Z-86
(2014)

PETITION NO: Z-86

PROPOSED USE: Single-Family Subdivision

ZONING COMMENTS:

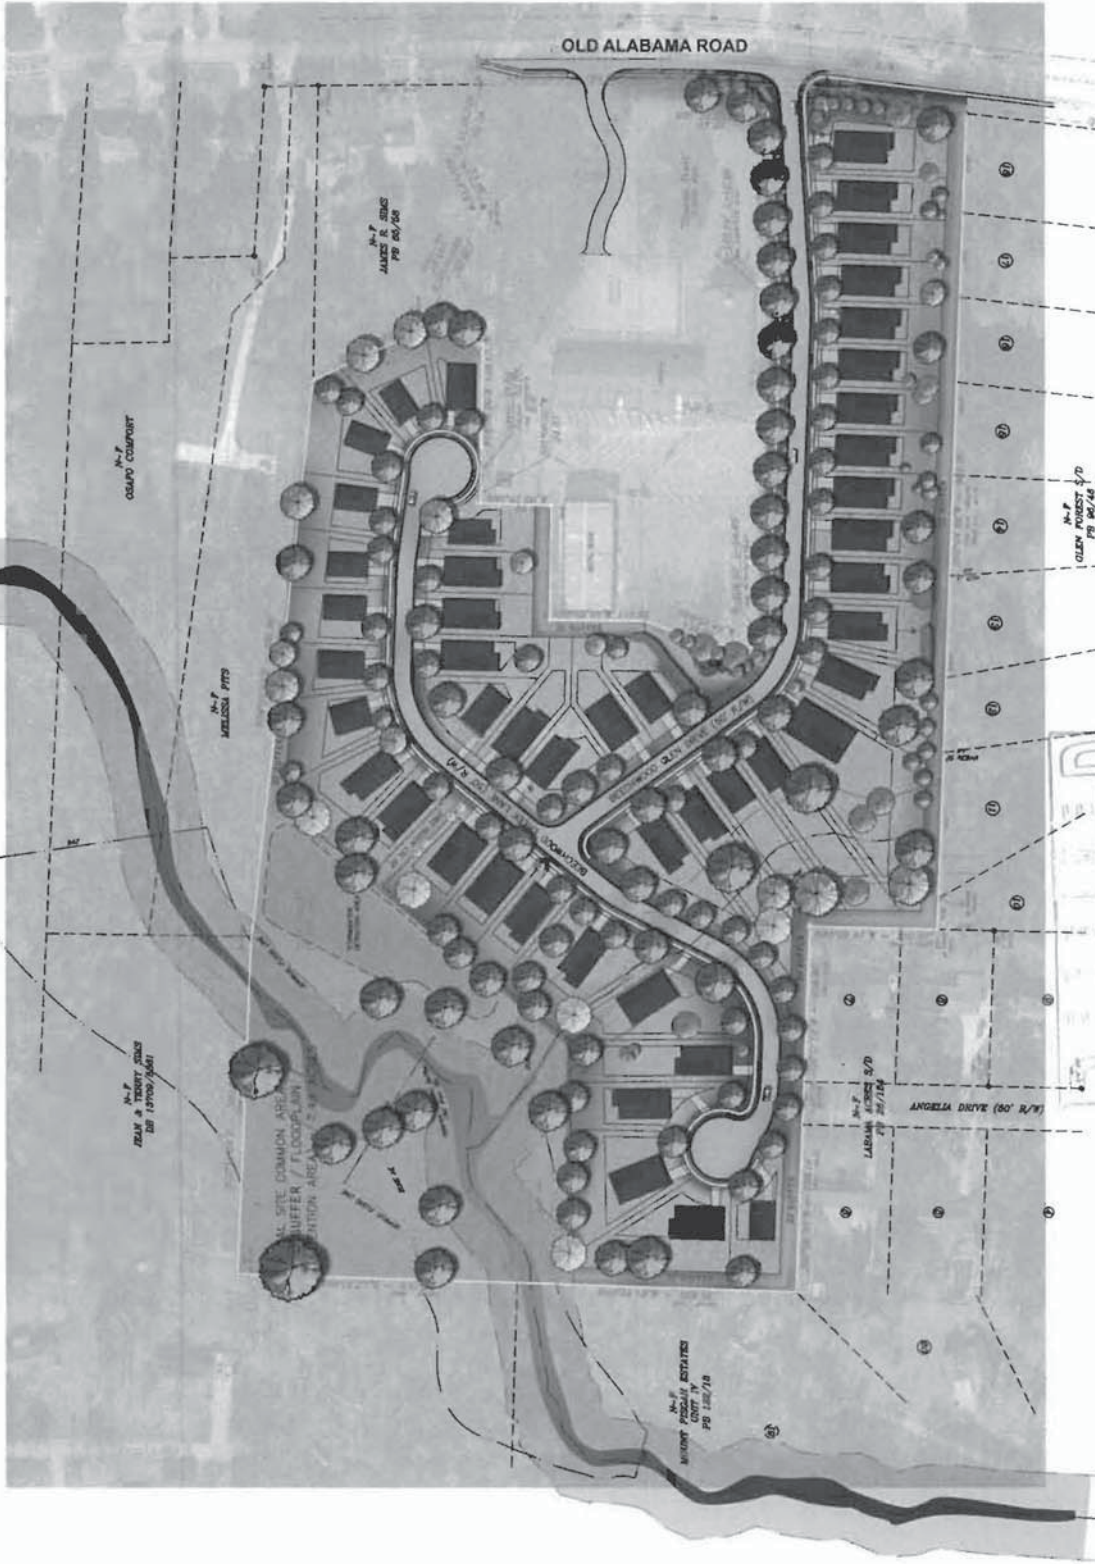
1. Reduce the front setbacks from the required 25 feet to 20 feet;
2. Reduce the minimum lot size from 7,000 square feet for lots 39, 40, and 41 to 6,250 square feet; and
3. Reduce the minimum lot width at the front setback line for lots 32, 33, 34, and 35 to 53 feet.

When projects contemplate less than 20 foot separation between units, guest parking shall be provided or the streets shall be labeled as a fire lane.

Additional Comments: Secondary water feed will be required to 6" main in Angelia Drive

Additional Sewer extension by developer required to uppermost property line (Old Alabama Rd). Sewer Comments: should be made available to church. Structures must be located so as to not encroach upon existing sewer easements and setbacks

- FEMA Designated 100 year Floodplain Flood.
- Flood Damage Prevention Ordinance DESIGNATED FLOOD HAZARD.
- Project subject to the Cobb County Flood Damage Prevention Ordinance Requirements.
- Dam Breach zone from (upstream) (onsite) lake - need to keep residential buildings out of hazard.

- Potential or Known drainage problems exist for developments downstream from this site.
- Stormwater discharges must be controlled not to exceed the capacity available in the downstream storm drainage system.
- Minimize runoff into public roads.
- Minimize the effect of concentrated stormwater discharges onto adjacent properties.
- Developer must secure any R.O.W required to receive concentrated discharges where none exist naturally
- Existing Lake Downstream _____.
Additional BMP's for erosion sediment controls will be required.
- Lake Study needed to document sediment levels.
- Stormwater discharges through an established residential neighborhood downstream.
- Project engineer must evaluate the impact of increased volume of runoff generated by the proposed project on receiving stream and downstream culvert at Thunderwood Road.

- Provide comprehensive hydrology/stormwater controls to include development of out parcels.
- Submit all proposed site improvements to Plan Review.
- Any **spring activity** uncovered must be addressed by a qualified geotechnical engineer (PE).
- Structural fill _____ must be placed under the direction of a qualified registered Georgia geotechnical engineer (PE).
- Existing facility.
- Project must comply with the Water Quality requirements of the CWA-NPDES-NPS Permit and County Water Quality Ordinance.
- Water Quality/Quantity contributions of the existing lake/pond on site must be continued as baseline conditions into proposed project.
- Calculate and provide % impervious of project site.
- Revisit design; reduce pavement area to reduce runoff and pollution.

- No Stormwater controls shown _____
- Copy of survey is not current – Additional comments may be forthcoming when current site conditions are exposed.
- No site improvements showing on exhibit.

1. This entire site discharges to the southwest into Pine Branch that traverses the southwest corner of the property. There is a small tributary to Pine Branch that crosses the southeast corner of the parcel. Both of these streams have 50-foot stream buffers and an additional 25-foot impervious setback.
2. The available building footprints for Lots 15-17 appear to be severely limited by the impervious setback buffer. Lots 24 & 25 do not appear buildable. A revised lot layout is needed to address these issues.
3. A 20-foot drainage easement will likely be required along the rear of lots 31-36 to limit offsite bypass of runoff. This will need to be taken into consideration if any perimeter landscape buffers are proposed.

Petition No. Z-18905
Meeting Date 2/21/10
Continued Site Plan referenced in letter

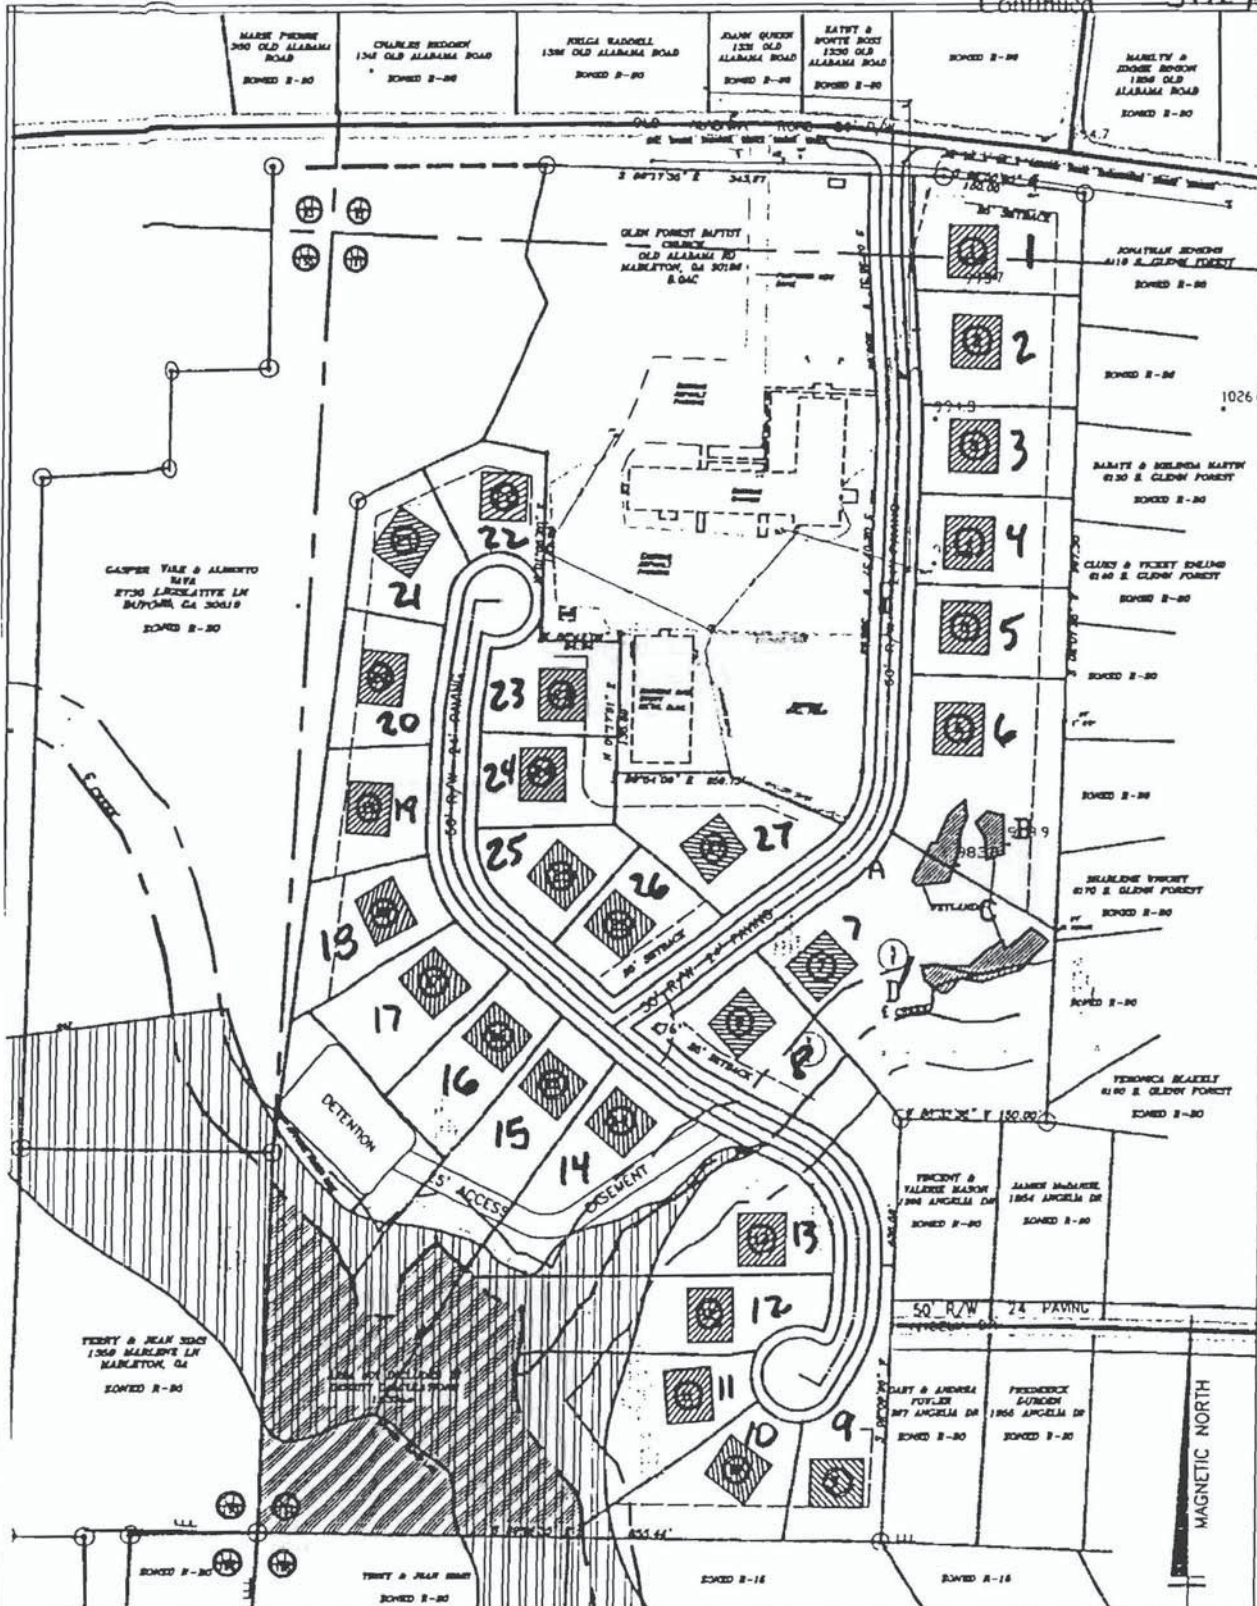
- 8) Revised Plan presented at Staff Zoning Analysis Review of 11-18-05 showing increased density from 6 lots to 8 in northeast and eliminating southwest cul-de-sac with ensuring rearrangement of lots and detention. Lot count has increased from 34 to 37. Detention / Water Quality-Best Management Practice is now without access from public road and has been moved into the Open Space area.

- 8.1) All previously made Drainage Comments remain in force.
 - 8.2) The relocation of the detention / Water Quality-Best Management Practice into an isolated area without public road access renders it unacceptable for Public / County perpetual maintenance. Recommend an operating manual be provided for County Review at Plan Review along with a funding arrangement.

- 8.3) This new plan shows the Open Space area increasing, but, at same time the detention / Water Quality-Best Management Practice located therein encumbering some of the Open Space. Suggest the Open Space calculations be refined to be compatible with plan.

- 8.4) The very small lots running against stream buffers and floodplain offer very little latitude for change in detail design. This must be considered a true conceptual plan subject to change. Therefore, Stormwater Management must reserve full right of review and comment for detail plans at Plan Review.
